Rapid Update 824

Grecale – BCM Parameter Alignment

DATE: August 4 2026

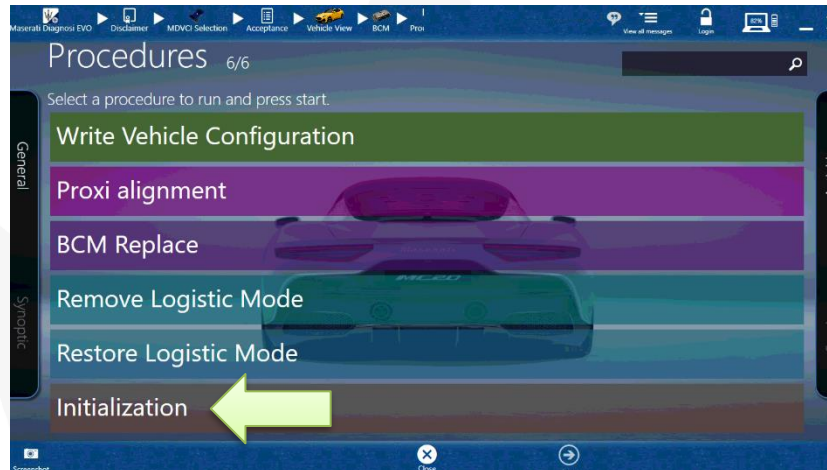
Due to a manufacturing anomaly, on some vehicles the timing parameter for locking the doors with the keys inside the passenger compartment may not be correctly configured. The function, known as the "**surfer maneuver**", can be selected by the customer and may therefore not be correctly set.

1. Always check ModisCS+ to see if the vehicle is involved in this action and if it has not been previously performed.
2. Before proceeding, make sure the **engine is OFF**.
3. Connect the 12V battery to the **Battery Maintainer**.
4. Using MD EVO, perform the following procedure: **BCM – Initialization**.

5. Follow the on-screen instructions.
6. Once completed, the vehicle can be released.
